**PLANNED UNIT DEVELOPMENT
& SUBDIVISION STAFF REPORT****Date: July 20, 2006****DEVELOPMENT NAME**

The Gates of Springhill

SUBDIVISION NAMEThe Gates of Springhill Subdivision (Revised),
Resubdivision of Lot 26**LOCATION**4272 Old Shell Road
(North side of Gates Drive [private street], 265'± West of
its East terminus)**CITY COUNCIL****DISTRICT**

SITE PLAN

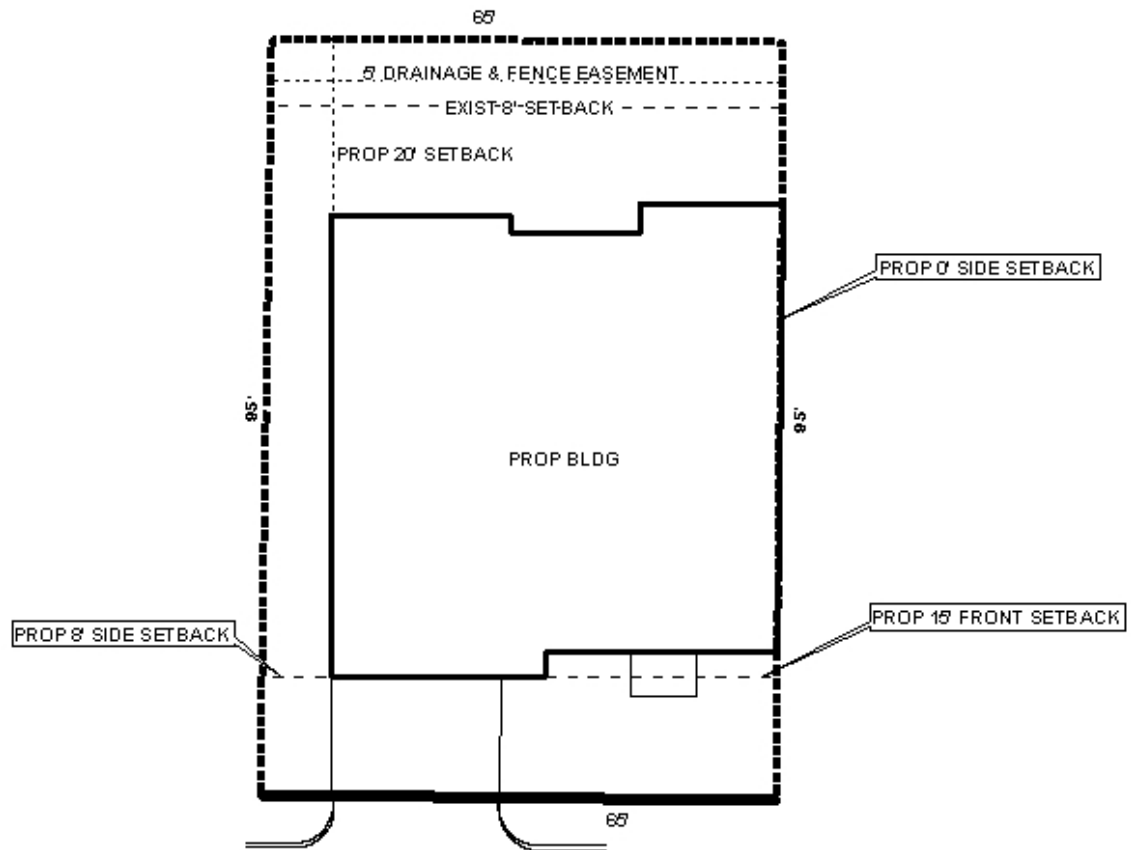
The applicant is requesting to increase the maximum allowable site coverage; the Ordinance allows 45% site coverage in an R-3, Multiple-Family Residence District. The approved PUD and Subdivision limited each lot to a maximum site coverage of 2,750 square feet, which is approximately 45% for lot 26. The applicant is requesting 51.8% site coverage, or 3,200 square feet. In single-family residential PUDs, additional site coverage is frequently requested. However, a typical condition is the submission of verification by an Engineer that the existing stormwater system, including designed and constructed detention, can accommodate the increased site coverage. Furthermore, it may be considered appropriate to place a note on the final plat and site plan stating that no increase of site coverage beyond 52% is permitted on this lot, if the application is approved.

The applicant is not requesting any changes to the existing setbacks, thus the front setback shall remain 15 feet, the West side setback 8 feet, the rear setback 8 feet, and the East side setback 0 feet.

Planned Unit Development: Based upon the preceding, this application is recommended for approval subject to the following condition: 1) that the Engineer provide verification that the existing stormwater system, if any for the development, including designed and constructed

Subdivision: The plat meets the minimum requirements of the Subdivision Regulations and is recommended for Tentative Approval subject to the following condition: 1) that the Engineer provide verification that the existing stormwater system, if any for the development, including designed and constructed detention, can accommodate the increased site coverage; 2) placement of a note on the final plat and revised PUD site plan stating the approved maximum site coverage for the site in percentage and square feet, and the required setbacks; 3) placement of a note on the final plat and revised PUD site plan stating that the site shall not be allowed further increase in site coverage; 4) provision of a revised PUD site plan to Urban Development, Planning Section prior to the signing of the final plat; and 5) full compliance with all other municipal codes and ordinances.
